# UNITED STATES PATENT AND TRADEMARK OFFICE

APPLICATION NO.	FILING DATE	FIRST NAMED INVENTOR	ATTORNEY DOCKET NO.	CONFIRMATION NO.
10/724,667	12/01/2003	Lee J. Brown	1614	2407
20676	7590	11/22/2005	EXAMINER	
ALFRED J MANGELS			YIP, WINNIE S	
4729 CORNELL ROAD			ART UNIT	
CINCINNATI, OH 452412433			PAPER NUMBER

**Office Action Summary**

## DETAILED ACTION

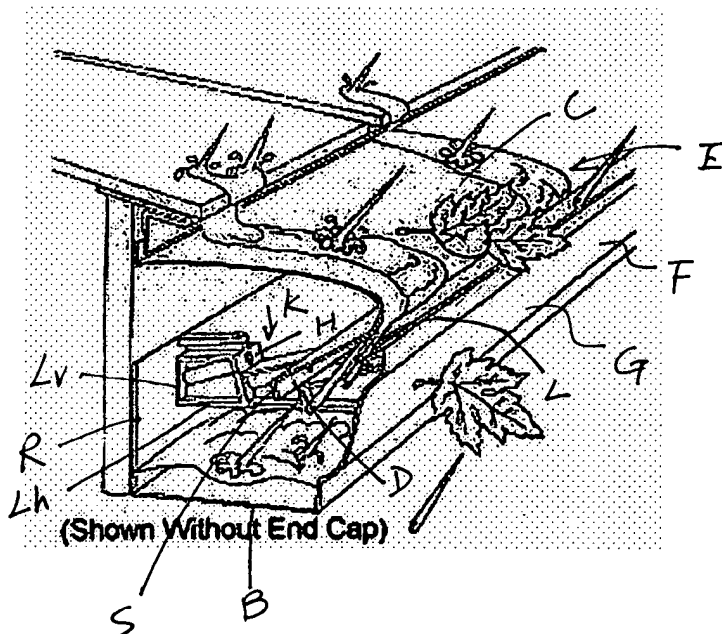
14. Claims 1-18 are rejected under 35 U.S.C. 103(a) as being unpatentable over Solution Company, Inc. (1/03) in view of Knudson '435.

Solution Company, Inc. shows and teaches a rain gutter assembly comprising: **(a)** an elongated gutter (G) having substantially U-shaped channel including a rear wall (R), a bottom wall (B) and a front wall (F), the front wall including an inwardly-extending lip (L) at an uppermost edge of the front wall, the lip having a reentrant flange extending backward and toward the front wall; **(b)** at least two support brackets (K) positioned and engaging between the front wall and the rear wall of the gutter, the bracket having a substantial L-shape body including a first vertical leg (Lv) having a mounting surface to contact the rear wall the of gutter and having a least one first bore (H) forming at least one passageway for receiving a connector which is a bracket fastener (3" screw) to provide a support means for securing the bracket and the gutter to the rear wall to the roof building surface, the support means having a surface inclined in a downward direction, and a substantially horizontal leg (Lh) positioned between the

rear and front walls of the gutter, the horizontal leg (Lh) having support surface having at least one second bore for receiving a fastener for securing the front edge of the gutter cover and a stepped portion (I) below the second bore providing a stop surface for abutment with and positioning relative to the bracket of the front edge of the cover, and the bracket having a front end providing an engagement means to engage and support the reentrant flange of the gutter front wall in a vertical direction; and (c) a cover having a plate-like cover body (C) overlying and spaced above the gutter opening, an inturned front wall (E) defining a curved front surface and terminate at a front edge of the cover body and lies between the gutter front wall and the gutter rear wall, and the front edge of the cover body having an inwardly-facing surface (D) being engaged and secured by a support surface (S) of the brackets, and the front surface of the cover body being spaced from the gutter front wall to define a gap about  $\frac{1}{2}$  inches therebetween to allow water flow into the U-shaped channel of the gutter. The Solution Company, Inc. does not show the rain gutter assembly including a gutter having a rear wall having a vertical height greater than that of the front wall such that the rear wall of the cover having a contact surface contacting the rear wall of the gutter and securing the rear walls of the gutter and the cover to the building surface as claimed, and the vertical leg does not carry a support means for engaging and supporting a rear portion of the cover. Knudson teaches a rain gutter assembly (12 or 92) comprising a U-shaped gutter (16 or 96) having a front wall (17 or 97) terminated at an inwardly upward front edge for engaging with the front brackets by fasteners (13) and having a rear wall (2) extending substantial vertical along the rear edge of the gutter to define a contact surface for abutting a substantially vertical building surface, wherein the rear wall (18 or 98) of the gutter may extend upward in a height greater than the height of the front wall of the gutter, a cover
